## Deadline 2 Representation 2<sup>nd</sup> June 2021

**David and Belinda Grant, [REDACTED], Middleton-cum-Fordley, Suffolk. [REDACTED]**  
**Holders of 'Best Small Farm in Suffolk' and special award for 'Best Conservation' by SAA since 2019.**

This is our Deadline 2 Summary Representation together with Annexes to the Planning Inspectorate regarding the proposed Sizewell C nuclear development (SZC) currently before the Planning Inspectorate under DCO submission.

# Heritage Assessment

Figure 2. The misapplication of the 750m buffer zone to the Route Z corridor, effectively excluding Leiston Abbey from the reckoning. Copied scalebars indicate the extent of the shortfall.

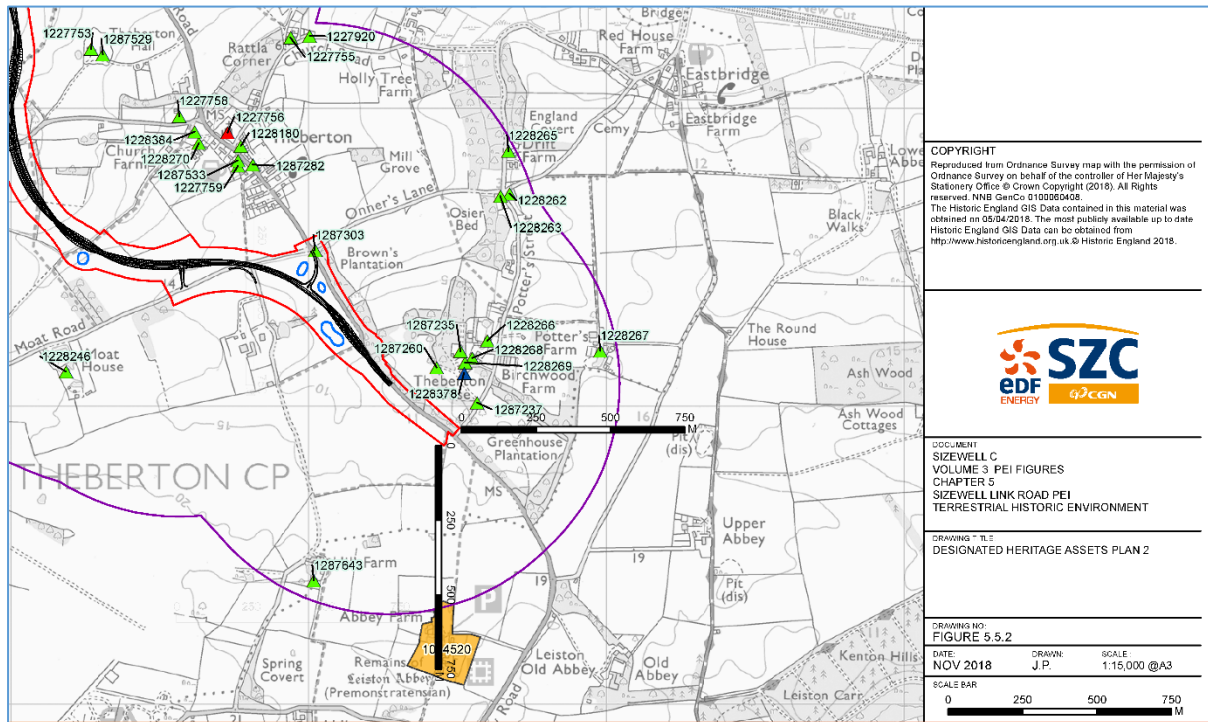
It should be noted that in generating their 750m buffer zone, EDF Energy have worked from the edges of the road line itself (shown in black on the plan in Appendix 1) rather than the edges of the working corridor (shown in red in Appendix 1). While for much of the route this approach makes little difference in terms of area, it does have significant implications for the assessment of Designated Heritage Assets at the eastern end of the route, as it effectively stops the study area buffer some 250m short of the recommended full 750m and therefore does not include the complex of Listed Buildings within the Leiston Abbey complex. This discrepancy is clearly illustrated in Figure 2, in which the scalebar from the EDF plans has been copied onto the buffer zone (Figure 2).

Figure 3. Route Z, showing the Listed Buildings and Scheduled Monument which lie within the recalculated 750m of the proposed road line. Compare Appendix 1, and note the inclusion of Listed Buildings in the Leiston Abbey complex.

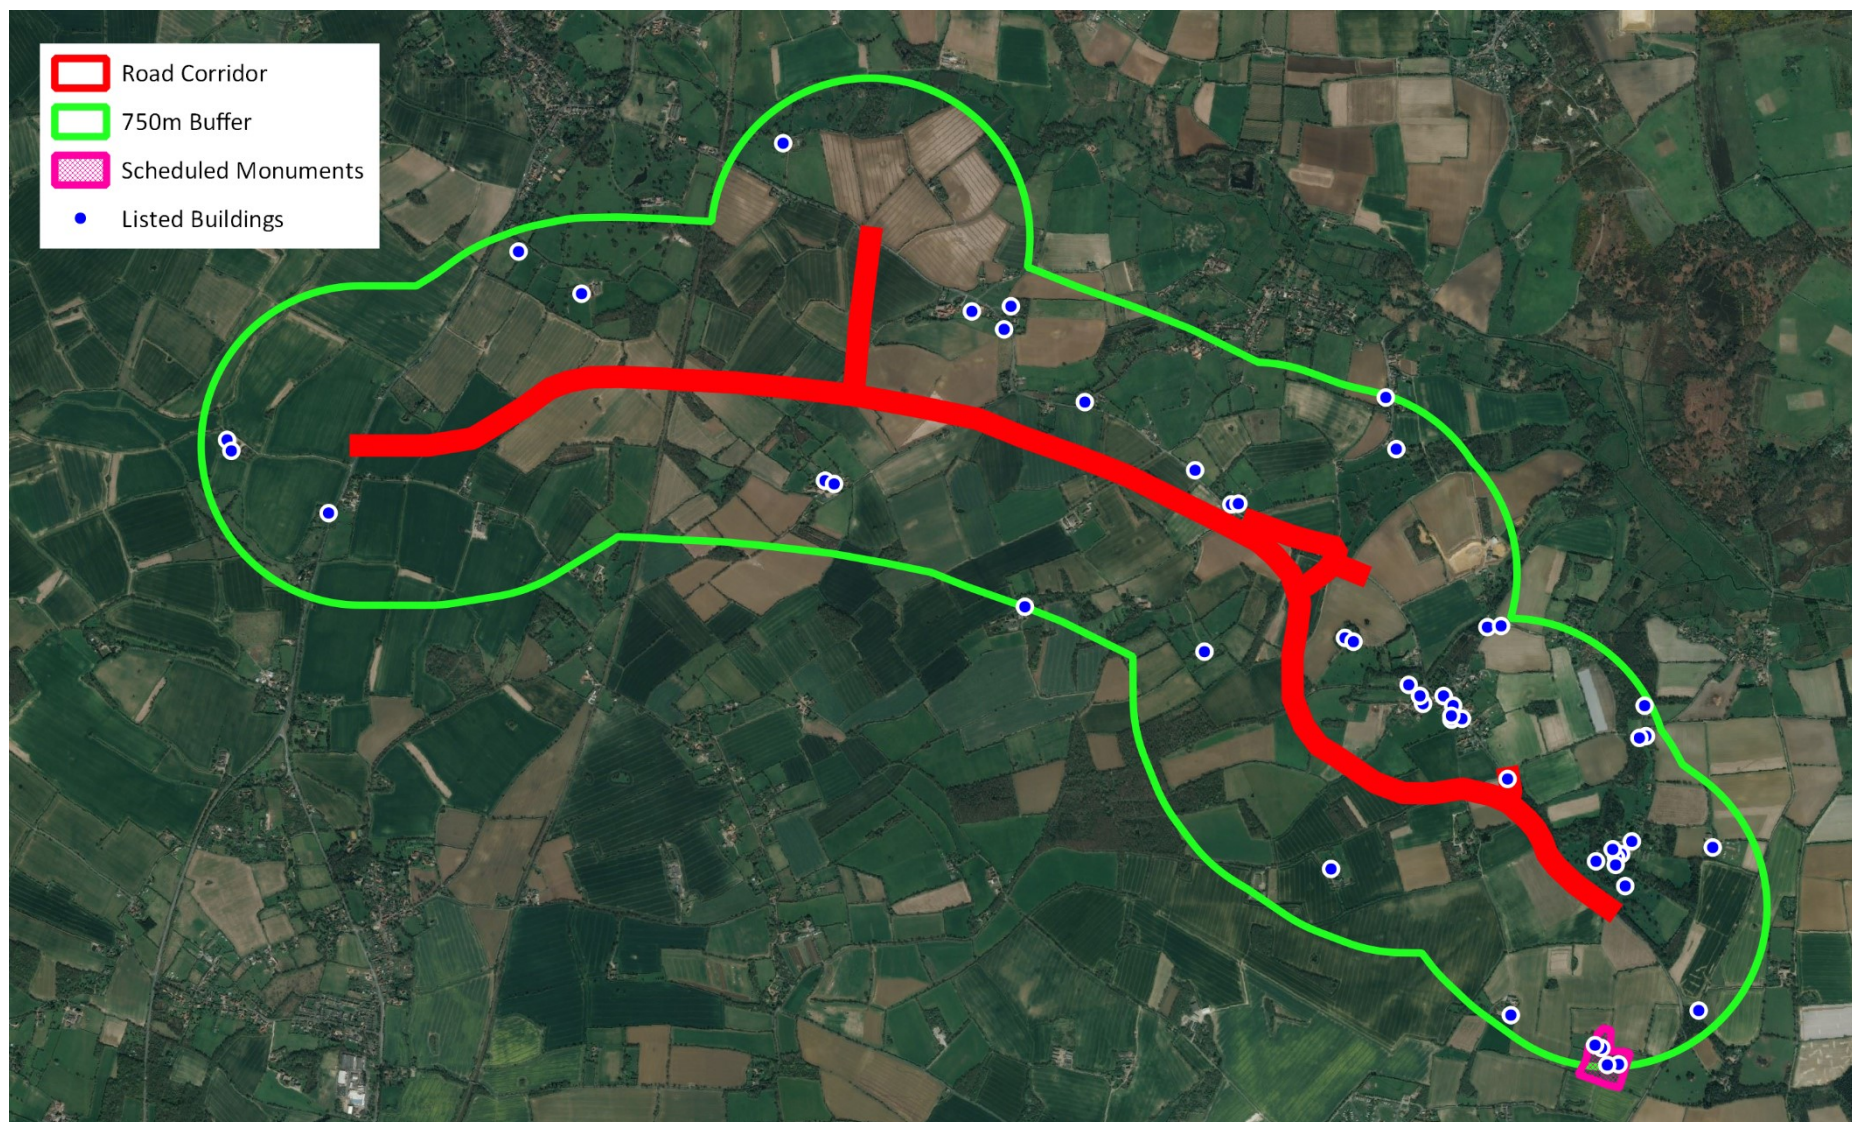
The desk-based assessment identified that there is one Listed Building which stands within the proposed width of the road, the Grade II-listed Gate and Gate Piers of Theberton House (LB 1287303), while an additional 45 Listed Buildings stand within the 750m buffer zone around the road. Of these, one is the Grade I listed church of St Peter, Theberton (LB 1227756) and one the Grade II\* listed Theberton House (LB 1228378). The remaining 43 buildings are listed at Grade II and comprise buildings associated with Theberton House and within the village of Theberton itself, as well as farmhouses and associated buildings and cottage (EDF Energy 2019 Vol. 2a, p. 274, paras 5.5.3–4). The locations of these buildings are illustrated in the maps reproduced in Appendix 1, and many of them would be affected by both the construction of the full length of the Sizewell Link Road and the shorter Theberton Bypass.

For the purposes of this assessment, an alternative map of the proposed route has been created applying the 750m buffer to the working corridor of Route Z, and this is reproduced here as Figure 3. As can be seen, this recalculated study area includes all of the Listed Buildings and Scheduled Monument described above, but crucially also includes an additional five Listed Buildings in and around the Leiston Abbey site. These additional buildings include the Grade I-listed ruins of the Abbey, the Grade II\*-Listed Moor Farmhouse and three more Grade II-listed buildings. As can also be seen, the majority of these buildings lie at the eastern end of the proposed and would therefore be equally affected by the full Sizewell Link Road and the reduced length of the Theberton Bypass. The full list of Designated Heritage Assets identified in this recalculation is given in Appendix 2, which should be compared to the list in the EDF Energy consultation documents (EDF Energy 2019 Vol. 2a, pp. 280–1, tables 5.5.3 and 4)

Figure 7. Route Z, showing the Listed Buildings which lie within the recalculated 375m of the proposed road line.

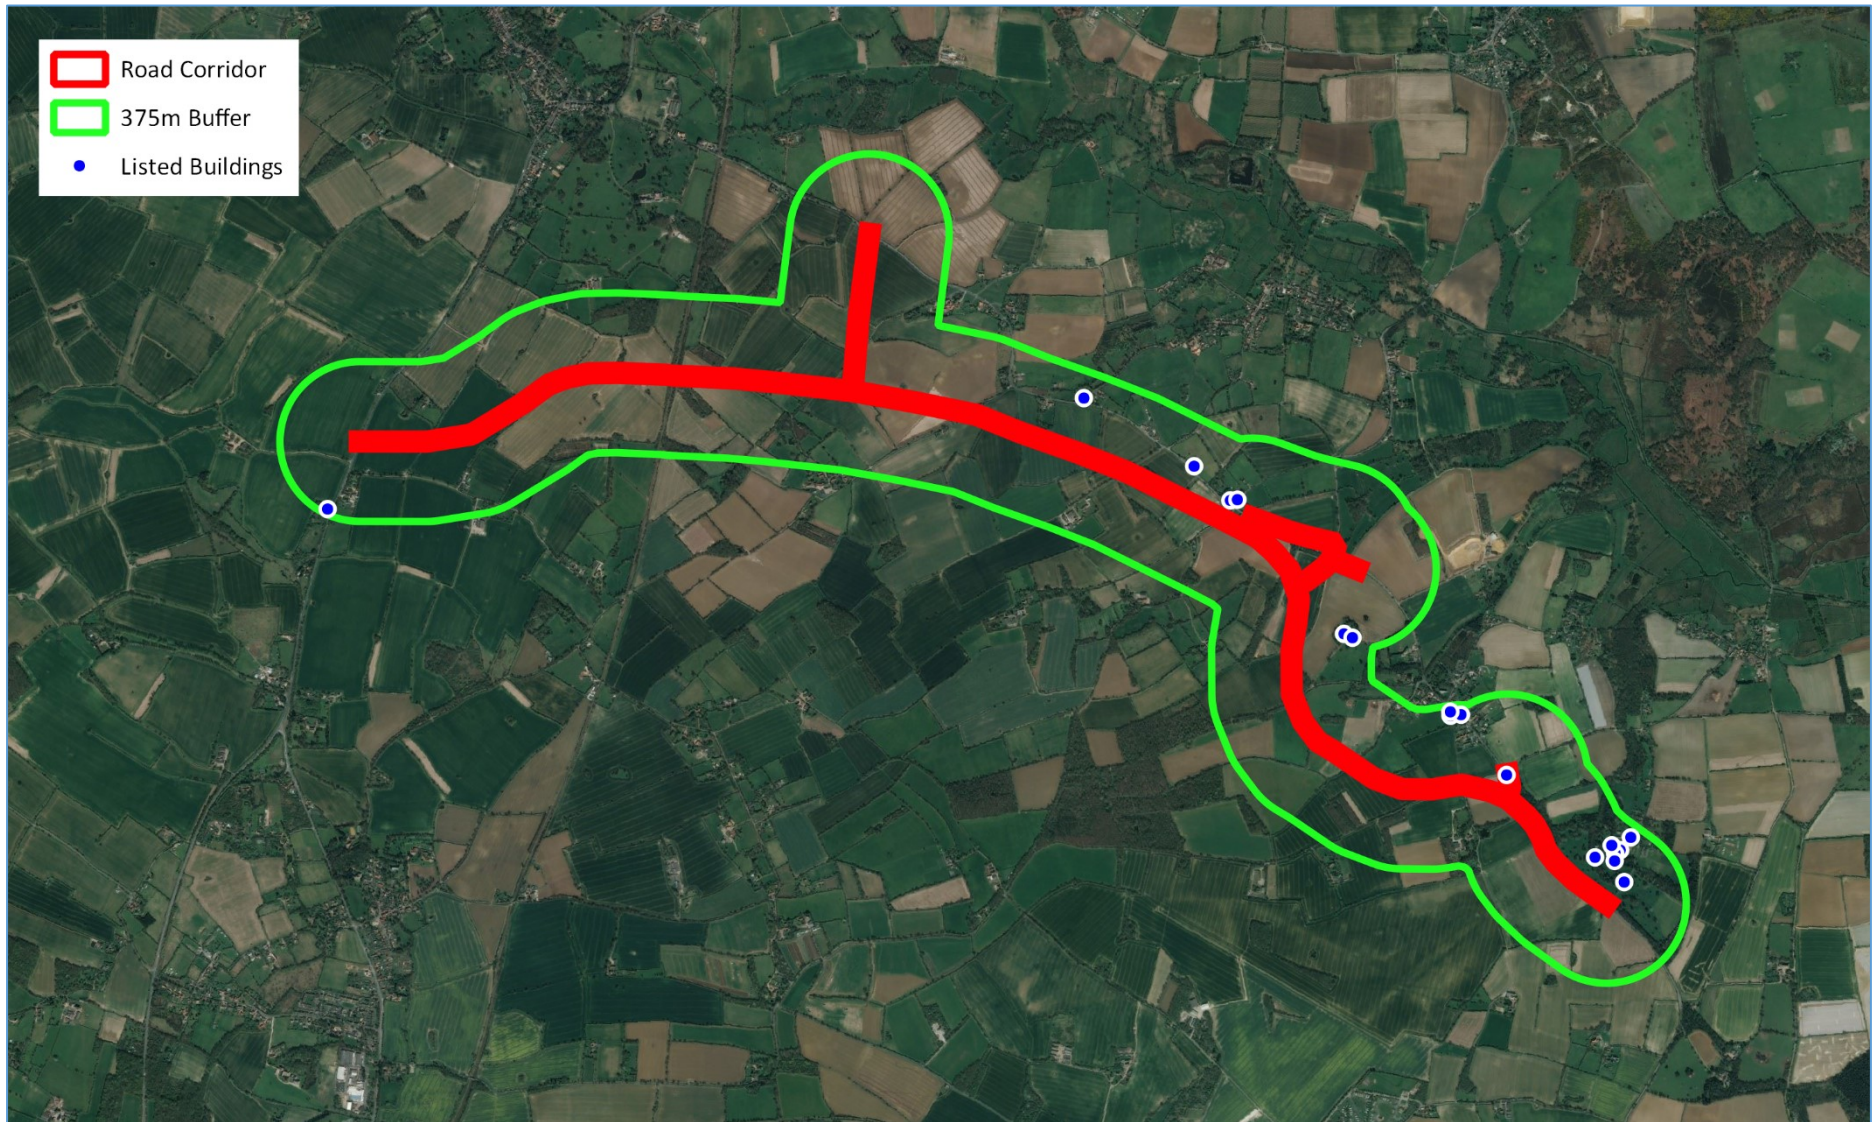
With this in mind, a more realistic assessment of the number of Designated Heritage Assets likely to be affected by each of the proposed routes might be achieved by applying a more limited buffer zone to the corridors, so that only Designated Heritage Assets which lie in closer proximity to the proposed routes are counted. In order to quantify this, the analyses based on a 750m buffer presented above were re-run using a 375m buffer (i.e. half the distance). The results of these analyses are also presented in Figure 6, with accompanying maps reproduced in Figures 7 (Route Z recalculated), 8 (Route W South) and 9 (Route W North).

As can clearly be seen, even with a buffer of half the size, the recalculated Route Z contains 1 Listed Building within its corridor and 18 Listed Buildings within the wider study area (Figure 7 and Appendix 5). These comprise 1 Grade II\* Listed Building and 17 Grade II Listed Buildings. The Leiston Abbey Scheduled Monument is not included in the reduced study area. It is also possible to see that the vast majority of the affected Designated Heritage Assets lie at the eastern end of the route, in the immediate environs of Theberton, and that these would be equally affected by the construction of the full Sizewell Link Road and the shorter Theberton Bypass.

Figure 10. The current extent and proposed extensions to Yoxford Conservation Area (SCDC 2019)

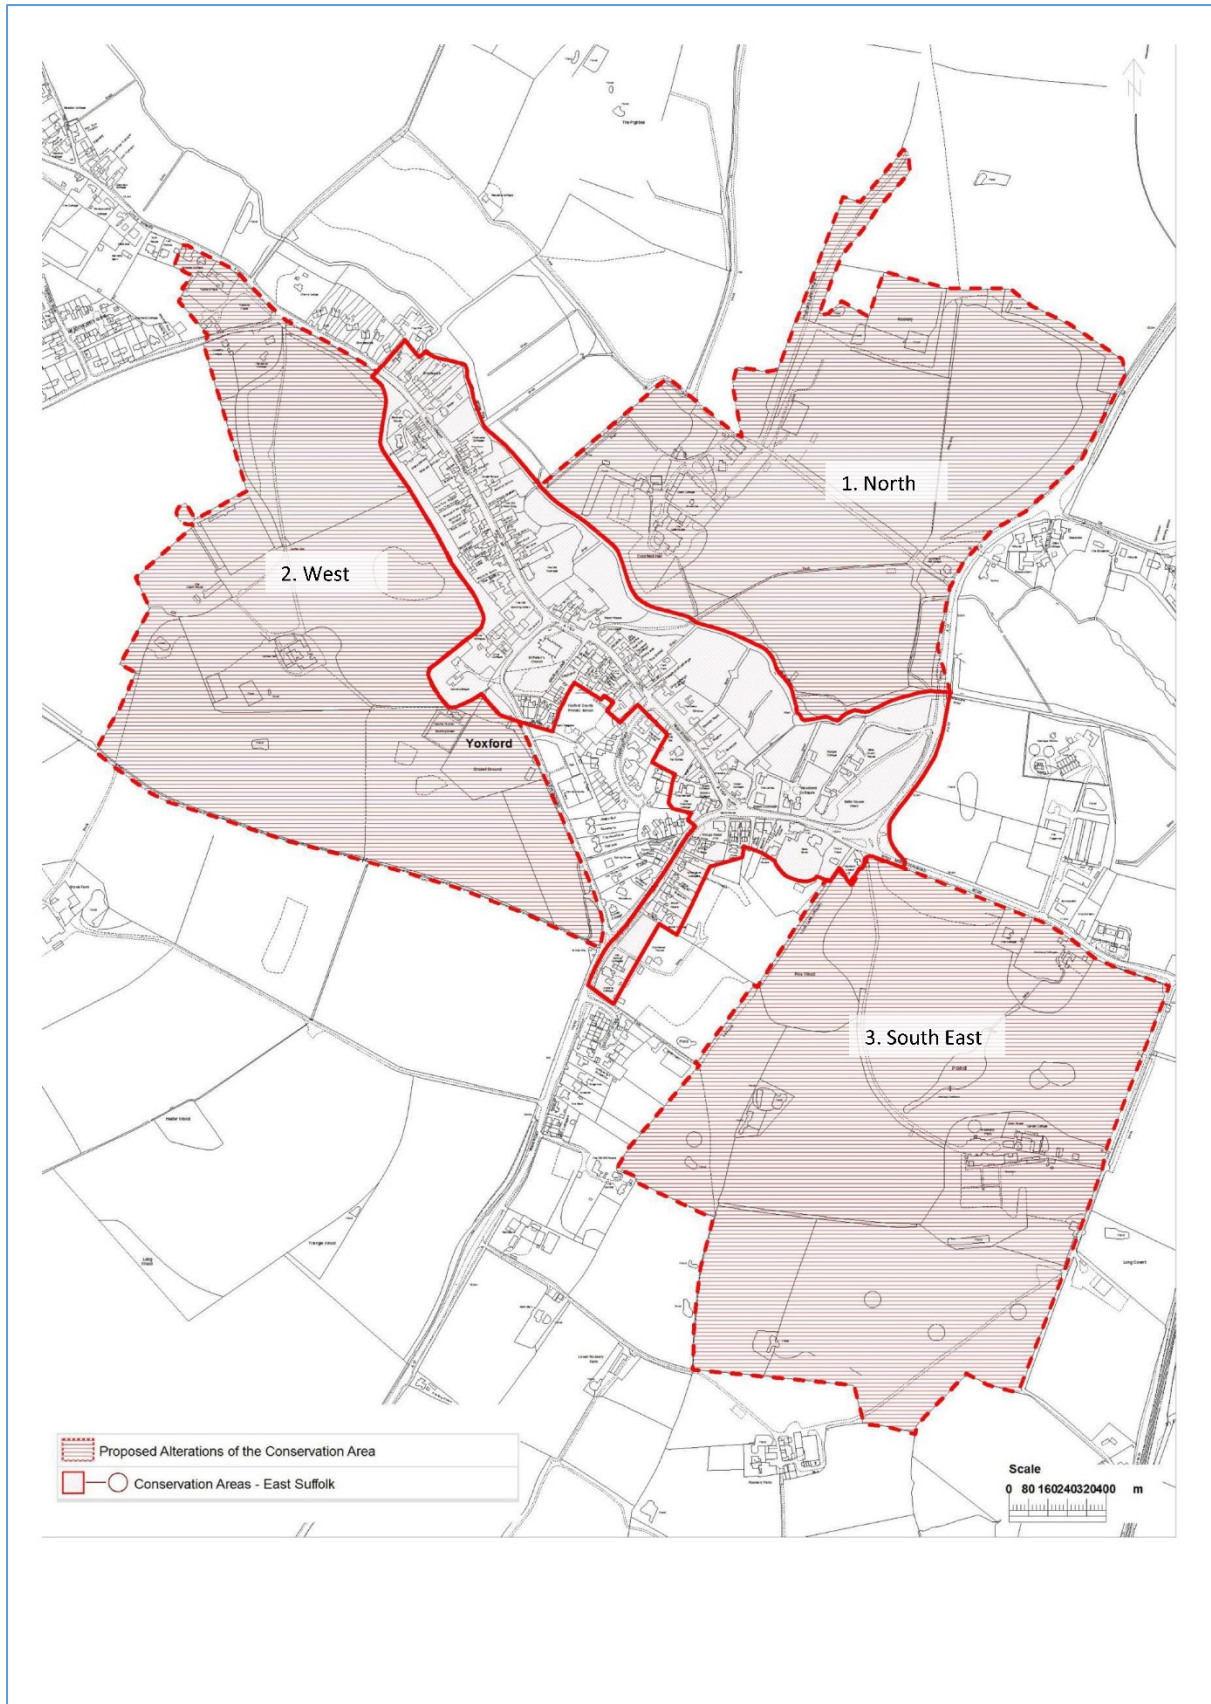
The desk-based assessment identified that there is one designated heritage asset within the proposed development area, specifically the Yoxford Conservation Area, which the report states 'extends into the eastern edge of the site boundary' (EDF Energy Vol. 2b, p. 588, para. 11.5.3). This statement dramatically downplays the relationship between the proposed development area and the Yoxford Conservation Area, as the entire length of the A12 as it currently exists within the proposed development area, including the existing junction with the B1122, actually lies within the boundary of the Conservation Area itself. Indeed, the eastern edge of the A12 marks the boundary of the Conservation Area between the A12/B1122 junction and the line of the River Yox to the north (Figure 10). It should also be noted that at the time of writing (March 2019) a proposed extension to the Yoxford Conservation Area is being consulted upon, which, if successful, would dramatically extend the Conservation Area to the north, west and south-east by incorporating the areas of Cockfield Hall Park, Grove Park and Rookery Park respectively (SCDC 2019; Figure 10).

During the Stage 2 consultation on the Yoxford roundabout, Suffolk Coastal District Council expressed the view that further work was required to assess the impact of the proposals on the setting of the Yoxford Conservation Area (EDF 2019 Vol. 1, p. 370, para. 16.4.6).

The information set out in the Stage 3 consultation does little to demonstrate that this issue has been taken any further, and acknowledges that the new roundabout would have an effect upon the setting of Yoxford Conservation Area as a result of the visibility of the proposed roundabout in views of and from the fringes of the Conservation Area (EDF Energy 2019 Vol. 2b, p. 590, para. 11.5.29). Although the A12 is already a busy road, that redevelopment of the junction, with associated earthworks, landscaping, road-widening and street lighting will significantly alter the character of the Conservation Area itself and its setting. If these proposals are accepted, the proposed development area of the roundabout will be surrounded to the west and south by the enlarged Conservation Area, meaning that that the potential impacts of the scheme on the Conservation Area will be proportionally greater too. At this stage, it is proposed by EDF Energy that any impacts could be mitigated by 'design and screening' (EDF Energy 2019 Vol. 2b, p. 591, Table 11.5.2), although no details as to how these measures might be used to mitigate the impact are set out.

Figure 2.2 – Dissected by SLR

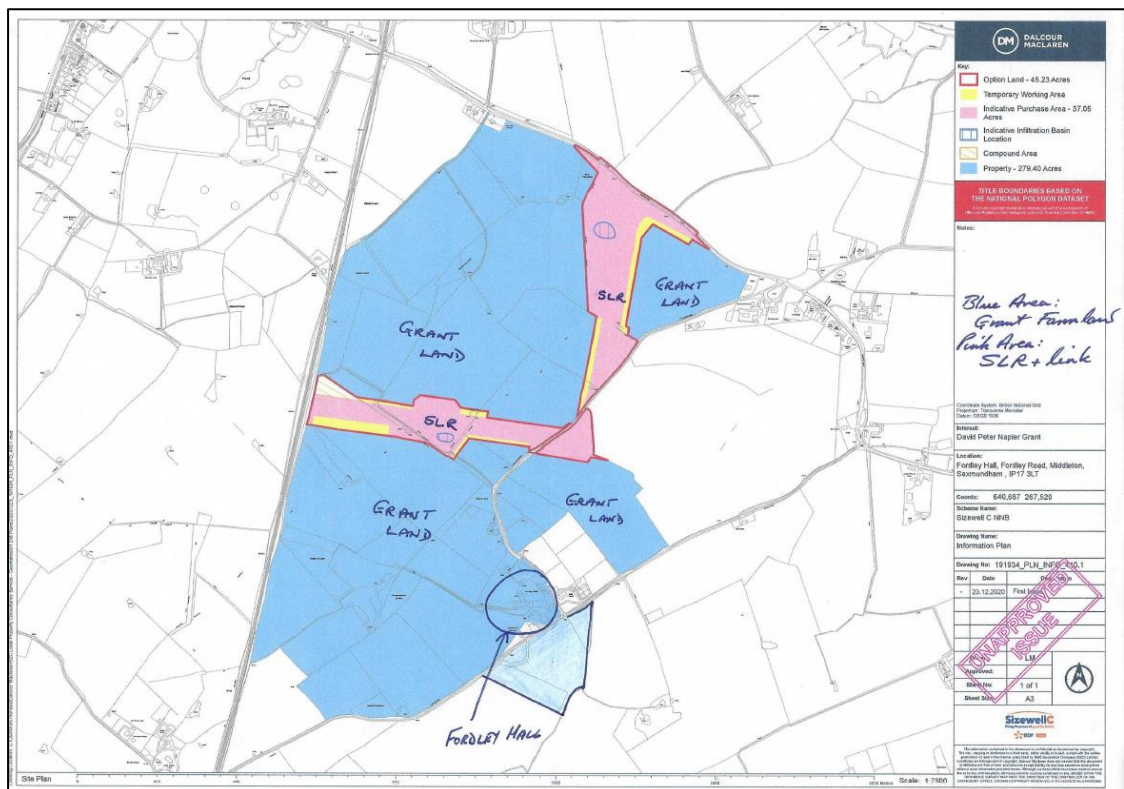
2.5 Figure 2.2 below shows how the proposed SLR dissects [REDACTED]; the resultant loss of acreage, 15% of the total arable area, and severance will impact negatively in the farm's viability.
